**REGULAR MEETING OF THE THIRD LAGUNA HILLS MUTUAL  
ARCHITECTURAL CONTROL AND STANDARDS COMMITTEE**

**Tuesday, May 28, 2019 – 1:30 p.m.  
Laguna Woods Village Community Center Board Room  
24351 El Toro Road**

**DATE:** May 28, 2019  
**FOR:** Architectural Control and Standards Committee  
**SUBJECT:** Variance Request  
Ms. Esther Wen of 3391-B (Malaga, P102A/P42)  
Patio Enclosure on Previously Extended Common Area

**DATE:** May 28, 2019  
**FOR:** Architectural Control and Standards Committee  
**SUBJECT:** Variance Request  
Mr. Richard Siao of 3461-C (Andaluz, P203A/P43)  
Room Extension on Previously Extended Common Area

EAST ELEVATION (PROPOSED)

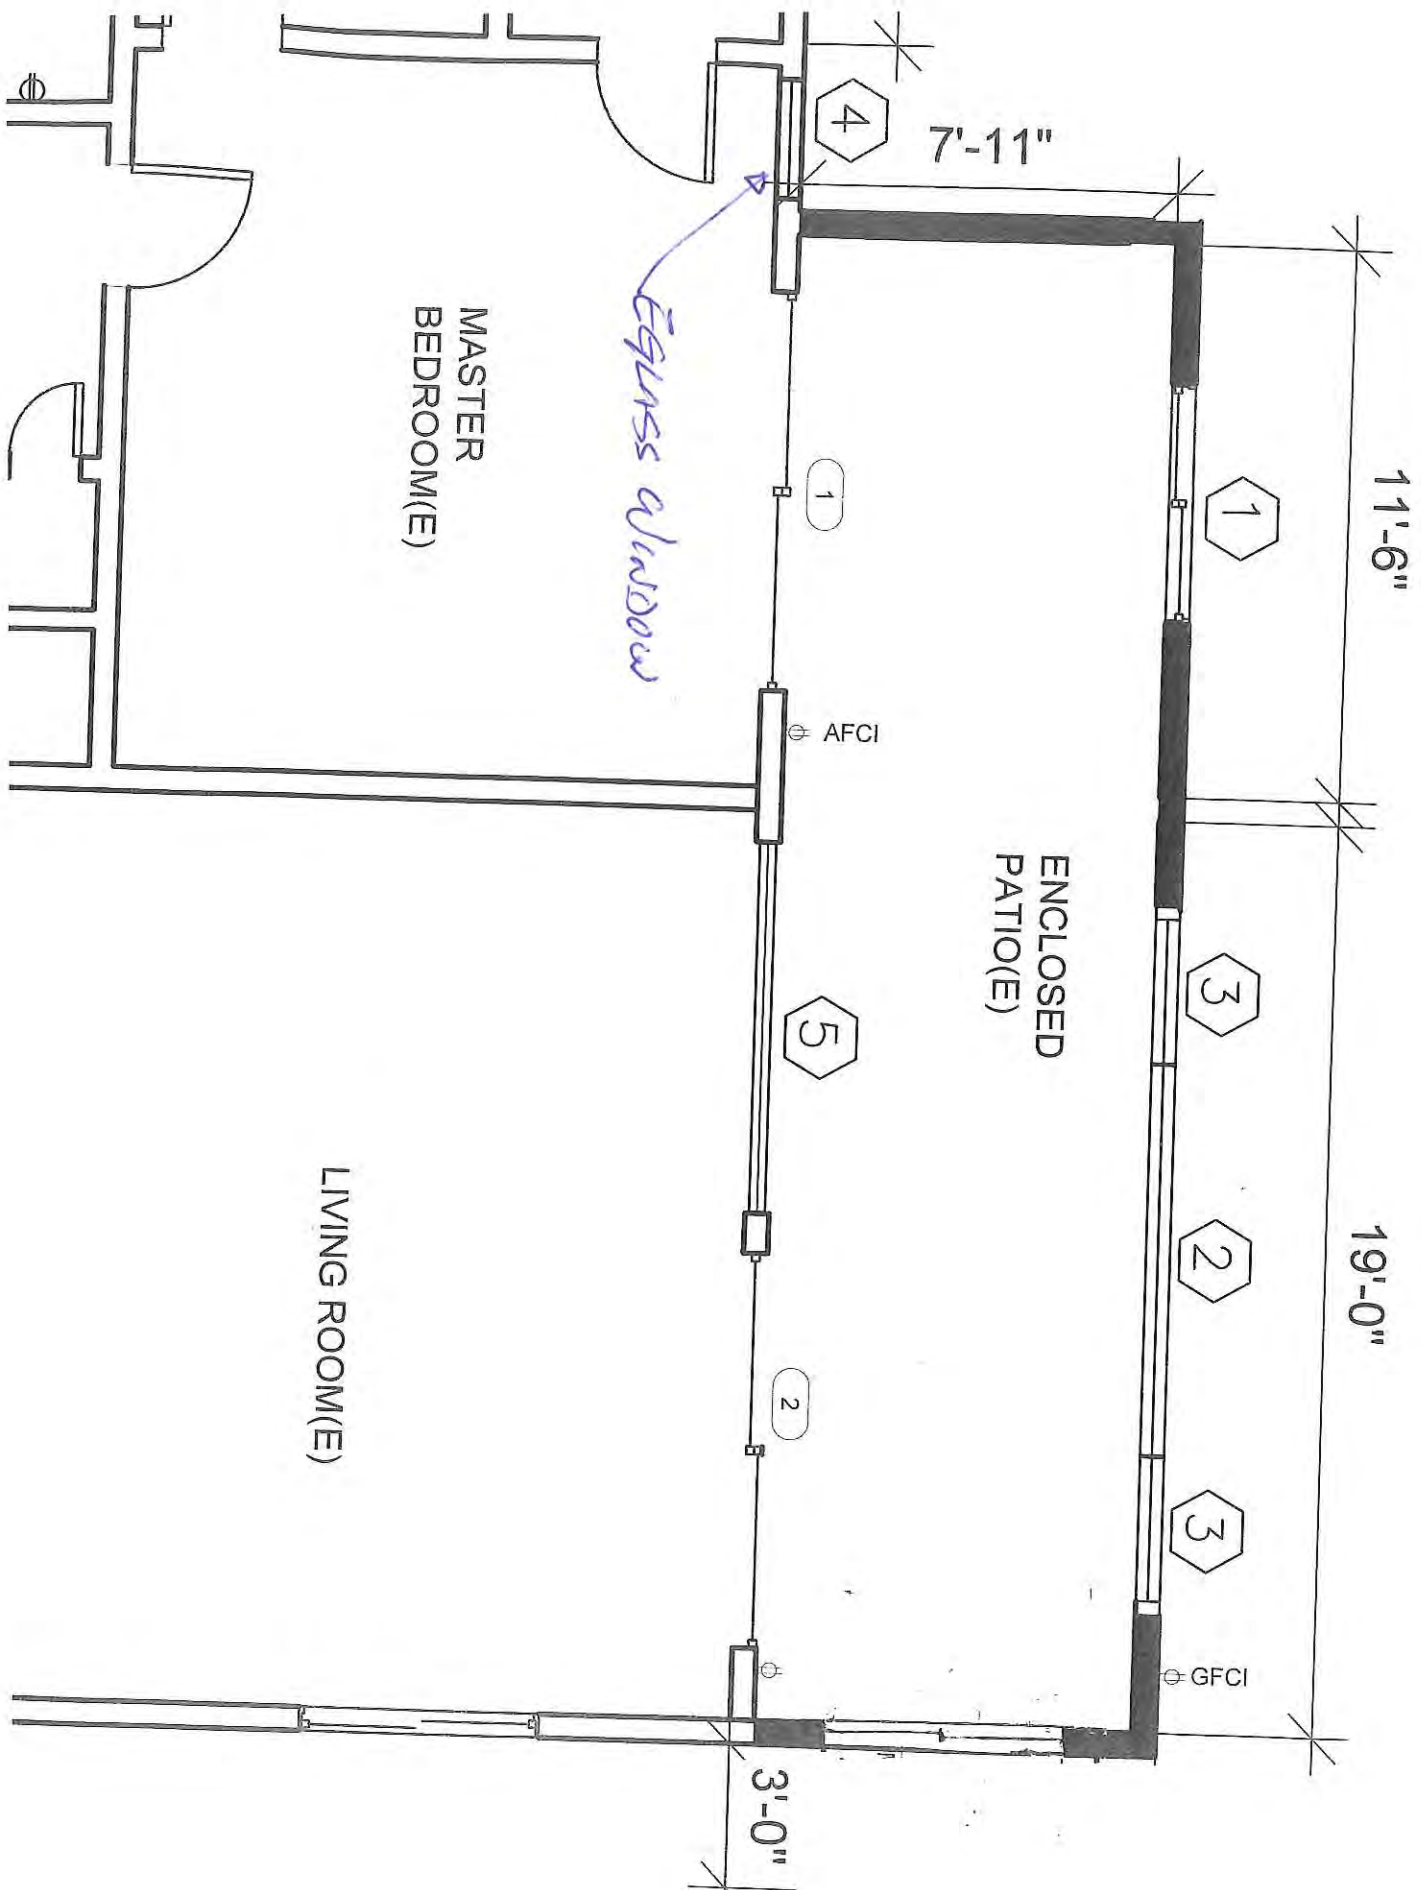
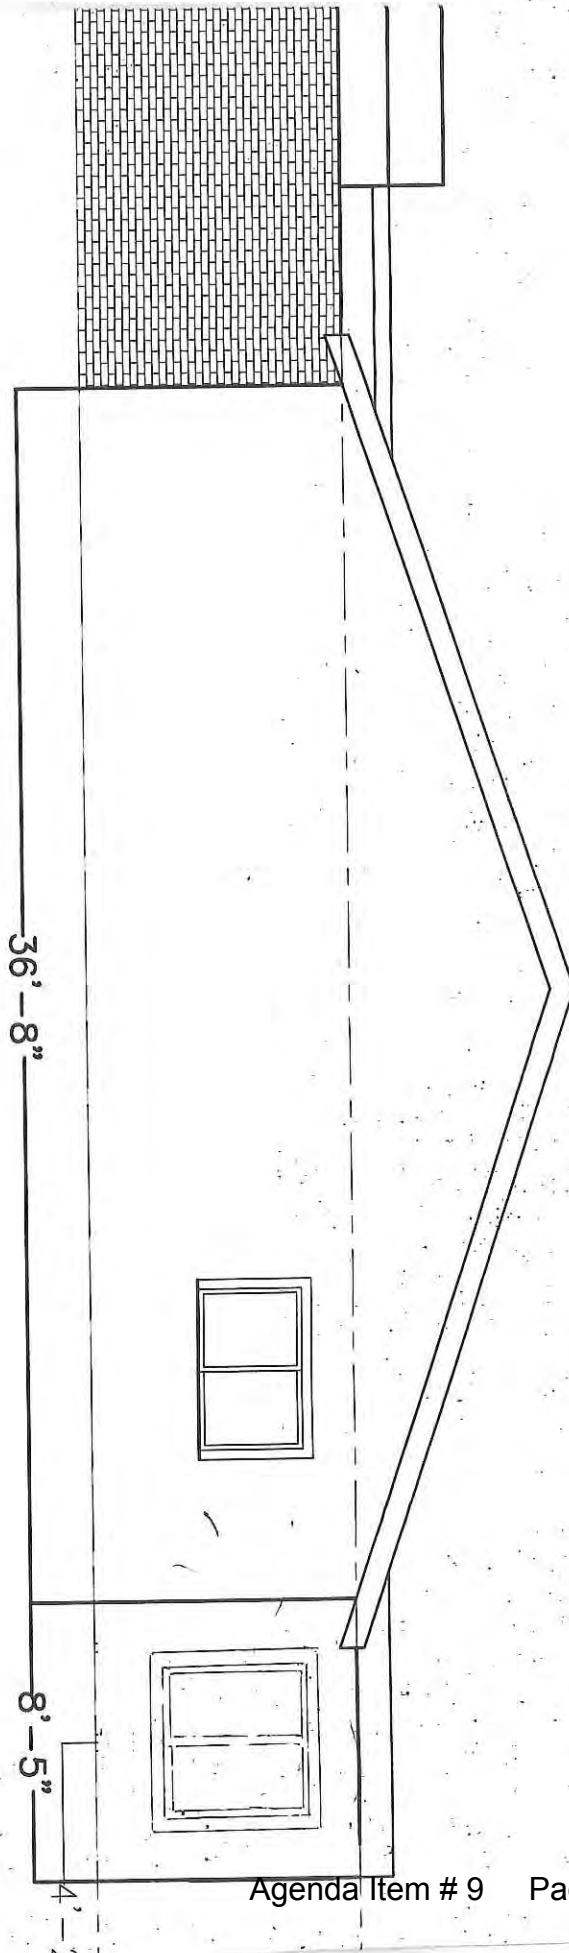
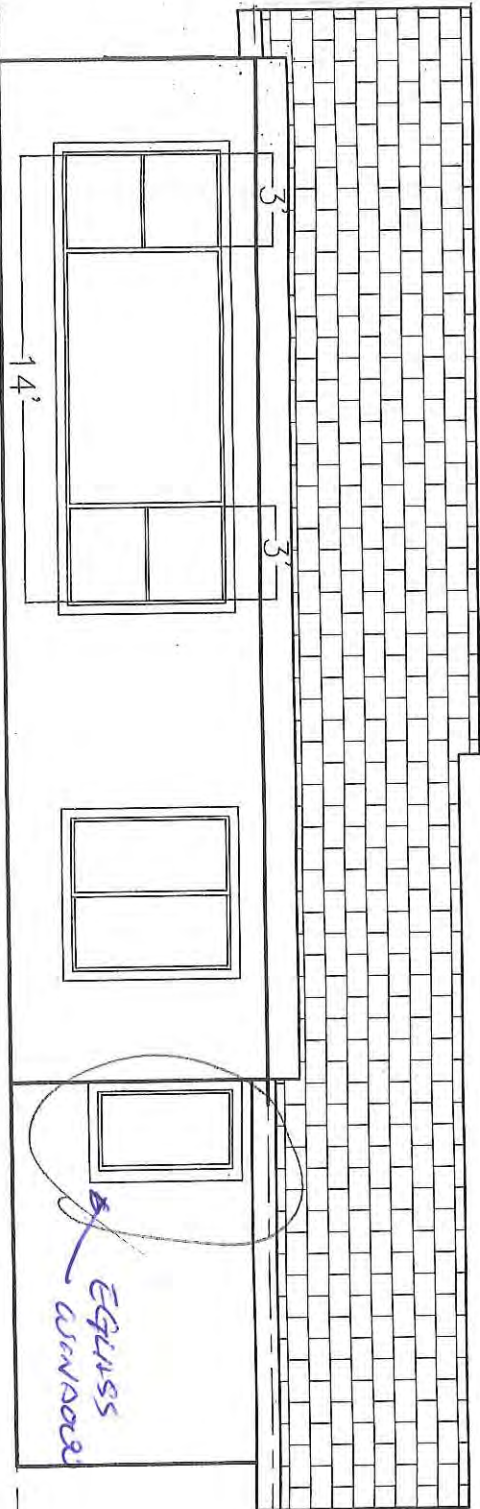
Mr. Siao is proposing to build a wood frame with stucco exterior room extension on the rear patio of his unit, using the same dimensions as the previously installed patio enclosure (32'-6" wide by 8' long).

The rear elevation will contain an 8' wide by 5'6" tall double hung window with two 3' wide side windows of matching height directly behind the living room area, along with a 5' wide by 5'6"

tall slider window located behind the Master Bedroom. The left (East) elevation will be a solid exterior wall with stucco finish to match the existing building. The right (West) elevation will contain a 4' wide by 6' tall window.

The new flat roof installation would be tied into the existing roof at approximately 9'; guttering and downspouts will be required to meet Mutual Standards.

As part of the project, a 19" wide by 48" tall window will be installed on the rear wall of the Master Bedroom to accommodate emergency egress requirements.

Staff recommends denial of this request in conjunction with current Third Mutual's Common Area Use Policy (RESOLUTION 03-18-146) "BE IT RESOLVED FURTHER, that no further alteration may be approved or constructed on any previously approved or "grandfathered" alteration that encroaches upon common area, other than like for like, that augments, enlarges, or changes the construction, purpose, or use of the previously approved or grandfathered alteration."

Staff recommends the Board deny the request to construct a room extension on a previously extended Common Area patio. Should the Board approve the request, Staff recommends it be with the conditions in Appendix A.
